Addendum - As Built Changes

PROJECT ADDRESS: 726 CAROLINA AVE
REQUEST TO ADD ADDITIOINAL 110 SQ FT OF LOFT SPACE AND EXTERIOR 2ND FLOOR BALCONY
LOFT OCCUPIES SPACE IN EXISTING FRONT 2-STORY FRONT ENTRY

DATE
					REVISIONS
					BY
					NO.
GOLDWORTH RESIDENCE 726 CAROLINA AVE. SUNNYVALE, CA					
PHILIP GOLDWORTH OWNER/BUILDER					
DATE: 8/11/2016					
SCALE:					
DRAWN:					
JOB:					
SHEET					
Project Data

1 FRONT ELEVATION (WEST)
A-3

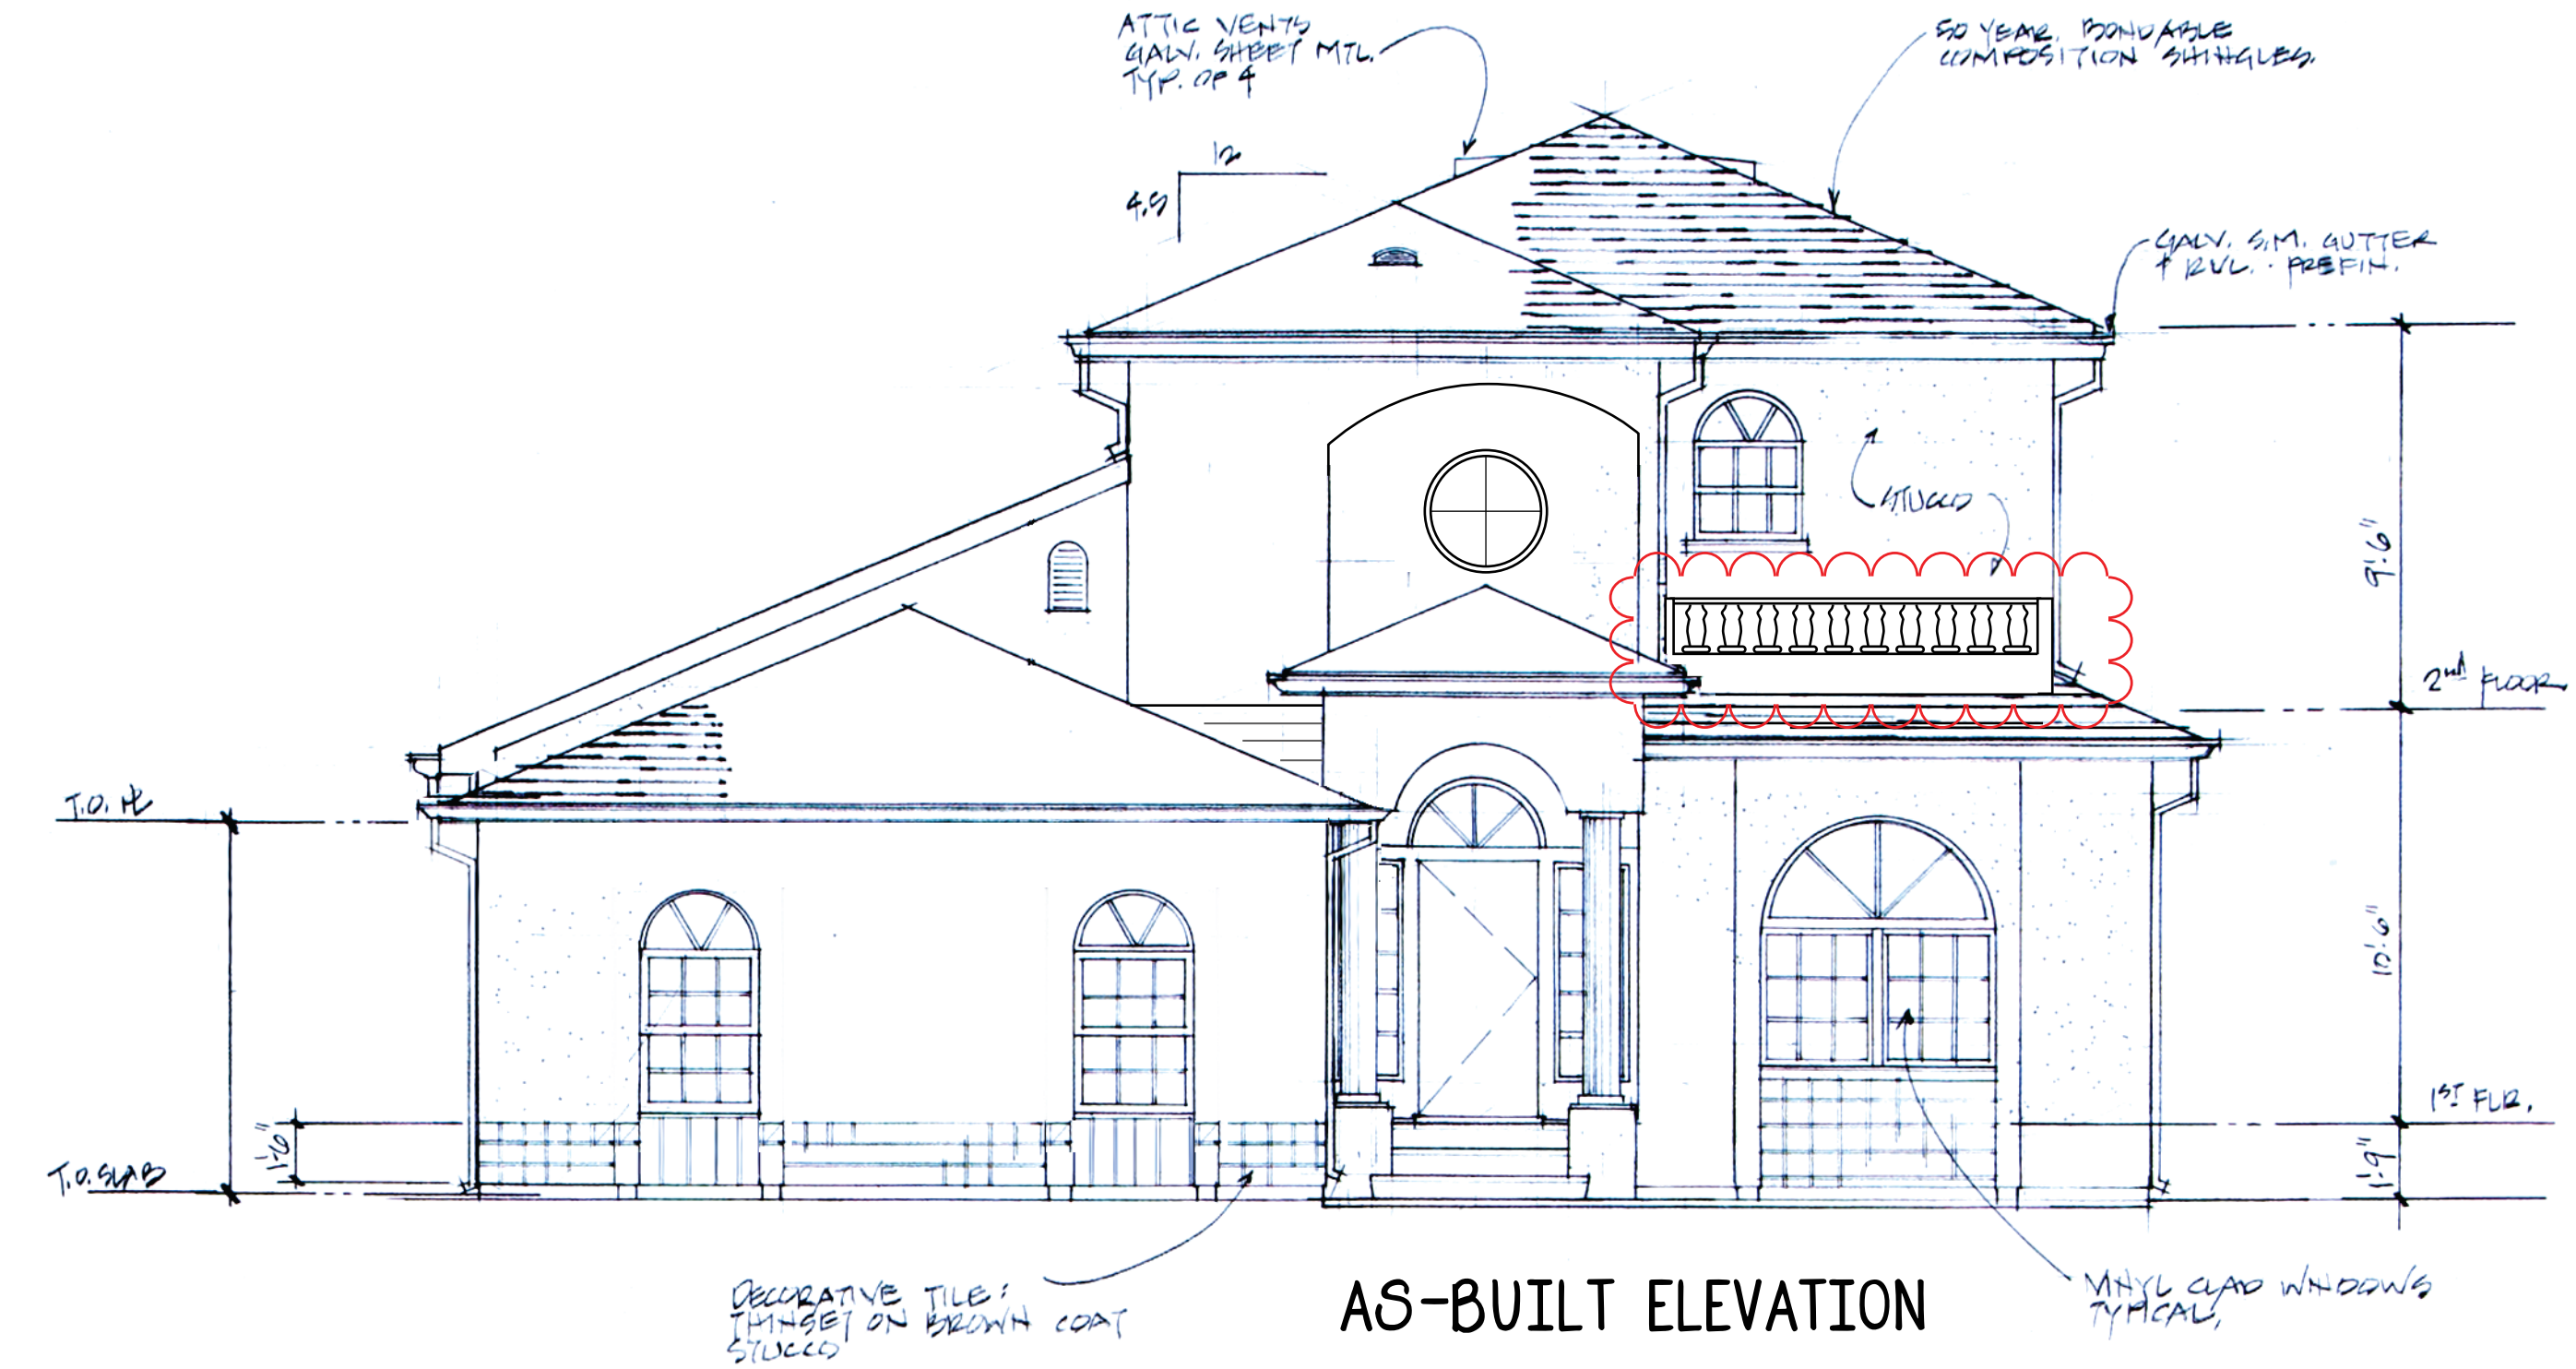
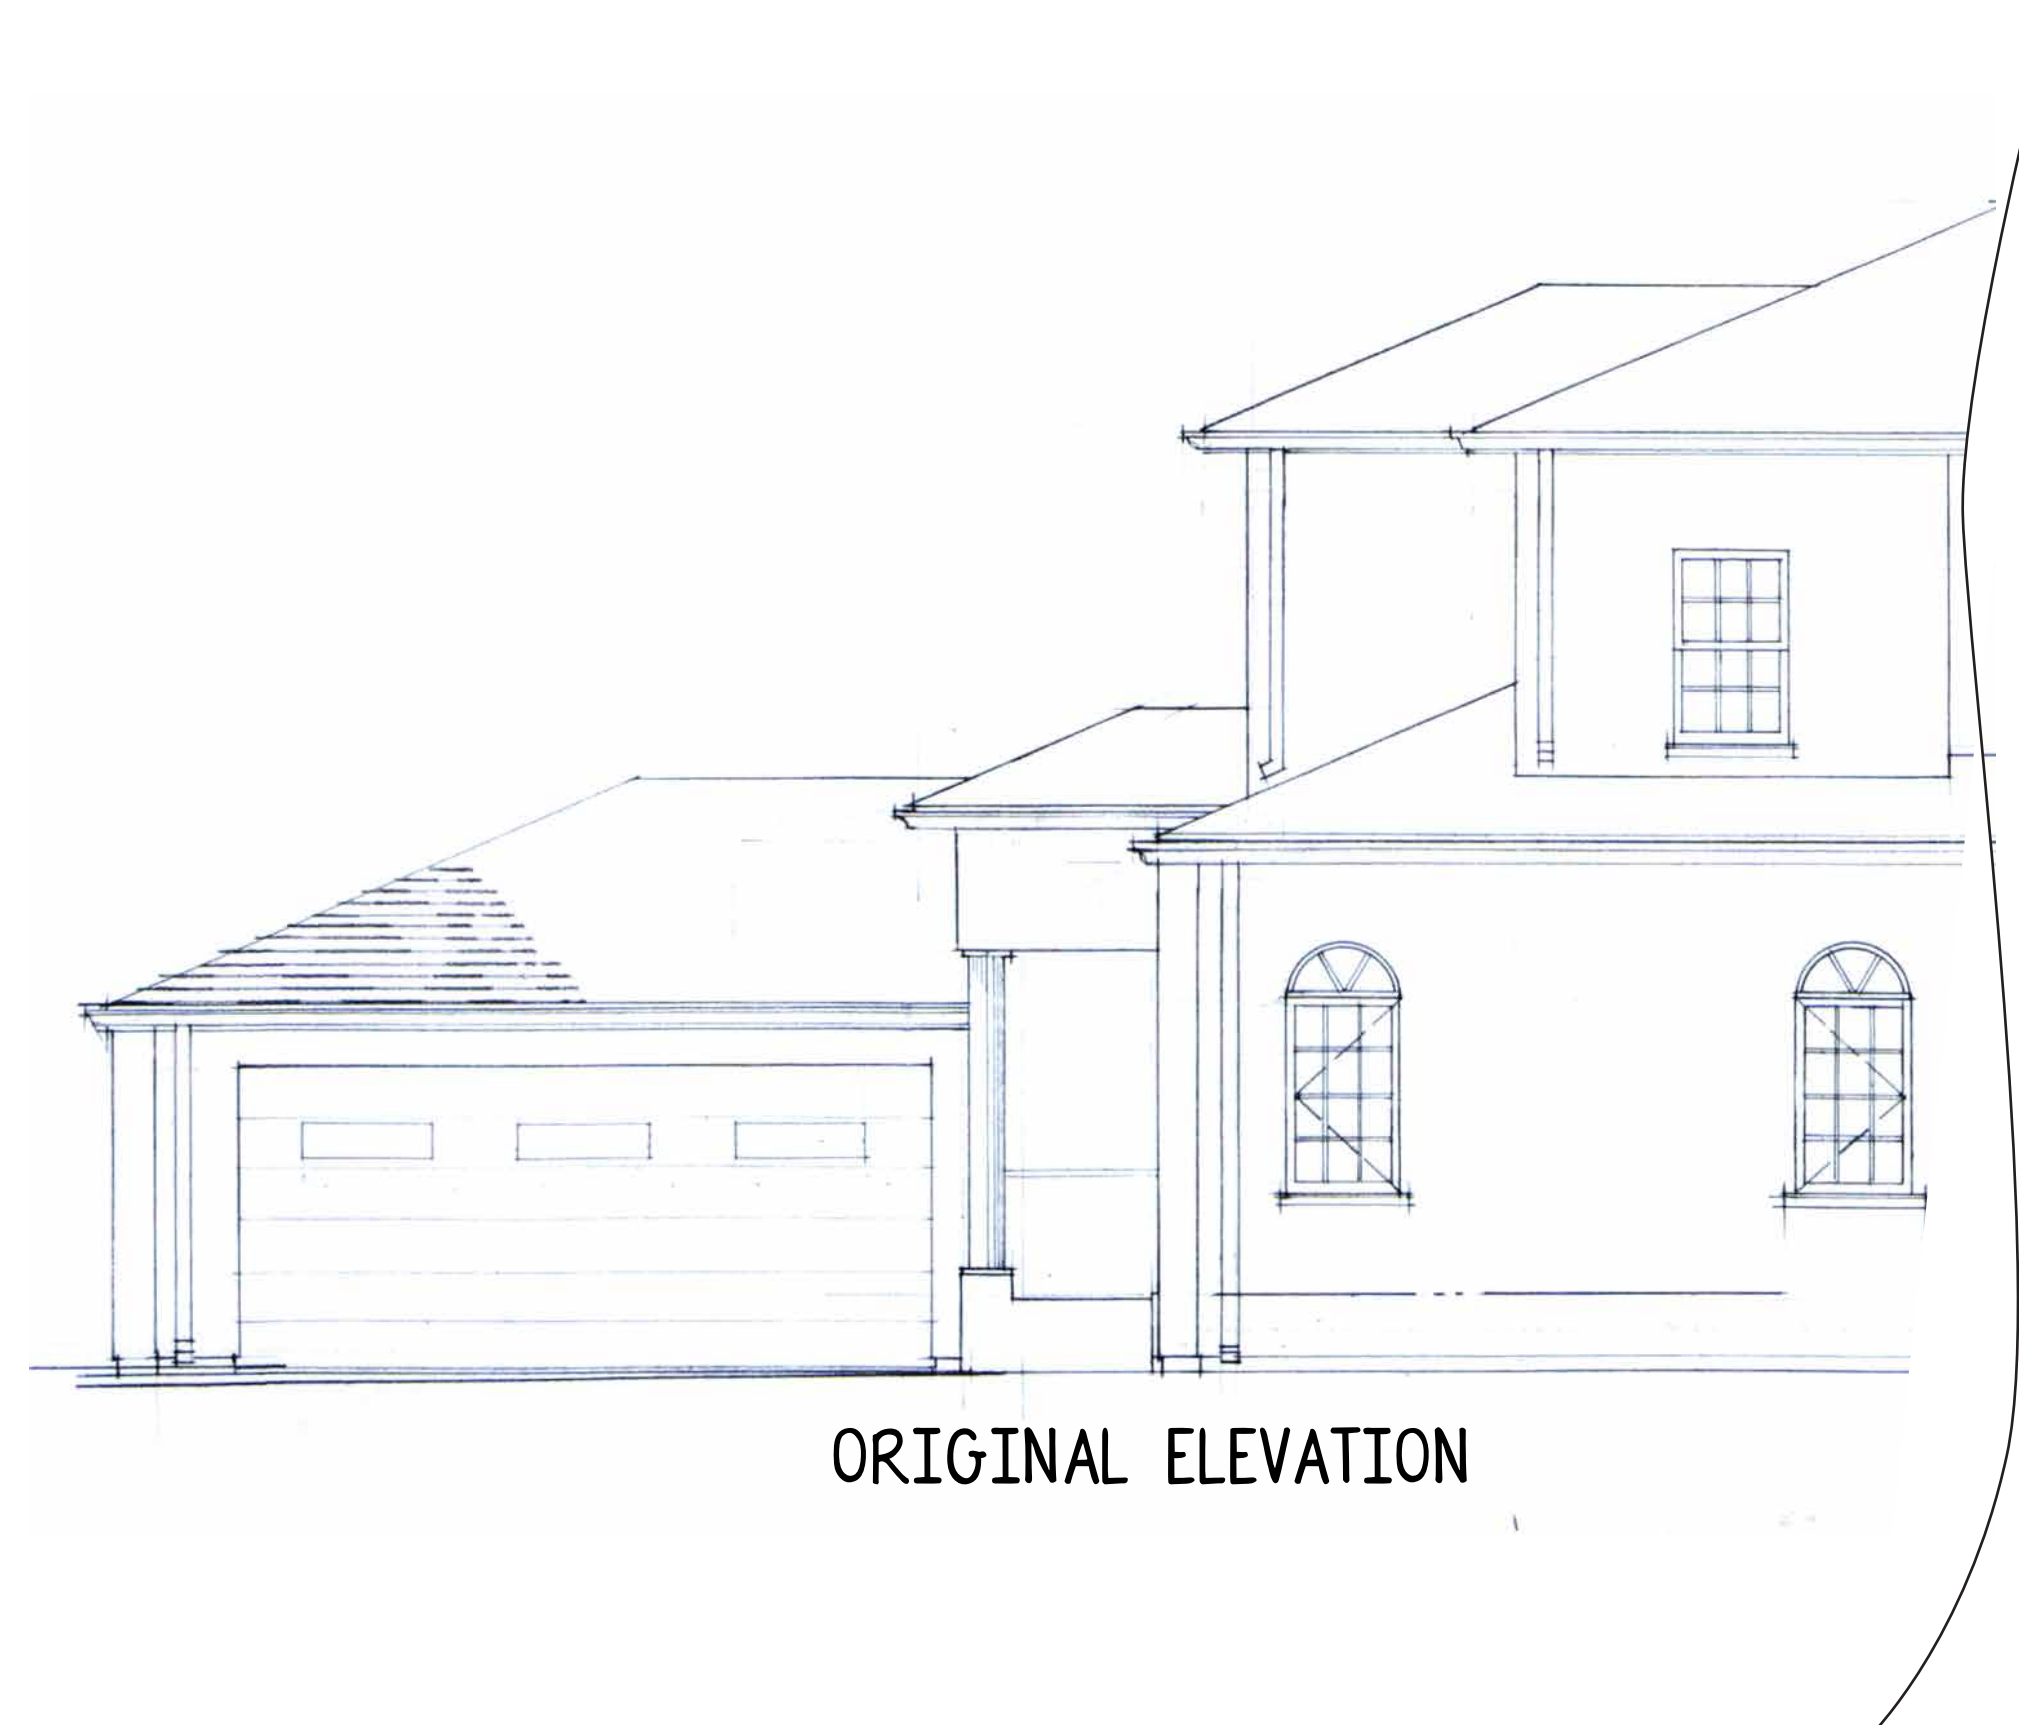
AS-BUILT ELEVATION
